# Access Compliance Report

## Public Rights-of-Way

Intersection ID: 10019175	Main Street: FOUR SISTERS LN	Cross Street: N/A	Location: E
ADA ID: 3F75A34C0278	Ramp Type: Perp	Initial Pass/Fail: Fail	Overall Compliance: No
Codes/Mitigation Info/Possible Solution		Field Measurements/Component Compliance	
Severity Score: 26.25

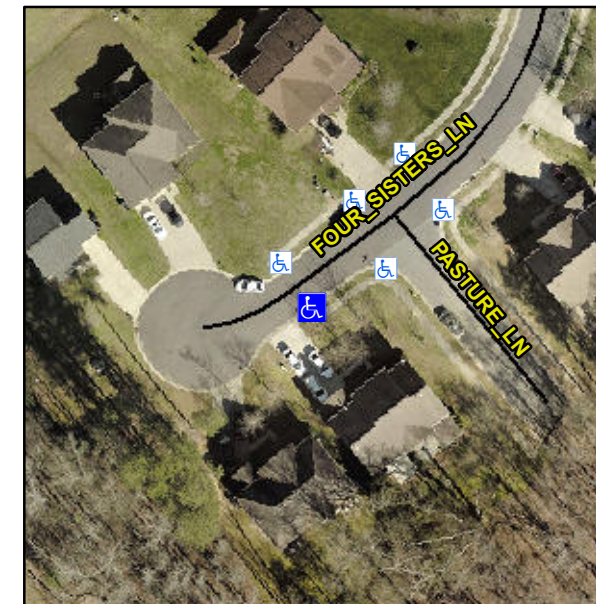
**Remove & Replace Entire Ramp.**

**Not Found, R304.2.2**

Compliance	Description	Data	Compliance	Description	Data
N/A	Ramp Length (in)	48.5	No	Ramp Slope (%)	15.2
Yes	Ramp Width (in)	50.0	Yes	Ramp XSlope (%)	2.7
N/A	Flare Type LT	N/A	N/A	Flare Type RT	N/A
N/A	Flare Slope LT (%)	N/A	N/A	Flare Slope RT (%)	N/A
N/A	Flare Traversable LT?	N/A	N/A	Flare Traversable RT?	N/A
N/A	Landing Length (in)	N/A	N/A	DWS Provided?	N/A
N/A	Landing Width (in)	N/A	N/A	DWS Contrast?	N/A
N/A	Landing Slope (%)	N/A	N/A	DWS Length (in)	N/A
N/A	Landing X Slope (%)	N/A	N/A	DWS Full Width?	N/A
N/A	Landing Curb? (Y/N)	N/A	N/A	DWS Offset (in)	N/A
N/A	Shared Landing?	N/A			
N/A	Gutter Ponding?	N/A	N/A	Gutter Slope (%)	N/A
N/A	Gutter Lip Ht (in)	N/A	N/A	Gutter X Slope (%)	N/A
N/A	Painted X Walk1?	No	N/A	Painted X Walk2?	N/A
	X Walk 1 Direction	To N		X Walk 2 Direction	N/A
N/A	X Walk 1 Width (in)	N/A	N/A	X Walk 2 Width (in)	N/A
	X Walk 1 Slope (%)	1.7		X Walk 2 Slope (%)	N/A
	X Walk 1 X Slope (%)	4.7		X Walk 2 X Slope (%)	N/A
